SUBMISION RE SSD-8996

AMENDED STATE SIGNIFICANT DEVELOPMENT APPLICATION – LORETO NORMANHURST SCHOOL REDEVELOPMENT (CONCEPT PROPOSAL AND STAGE 1)

OBJECTION TO PROPOSAL

(See photo below)

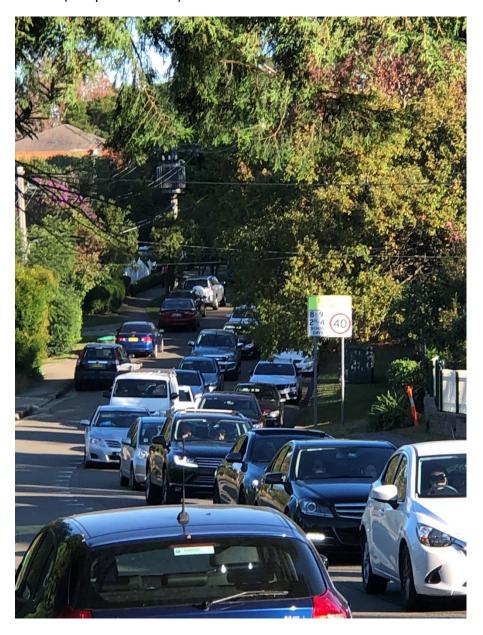
- with such an increase in numbers! On 11 May 2020, Loreto brought school pickup traffic from the school oval gates onto MPA for exiting with a left turn onto PHR from MPA. The attached picture shows part of the congestion. The line of cars was stopped for an estimated half a kilometre along MPA. Cars wishing to pass in the

opposite direction to reach their homes or the Adventist Retirement Village were unable to move. Consequently traffic was queued in lane 1 of PHR leading up to MPA. Cars wishing to leave their properties to drive towards PHR were also unable to do so.
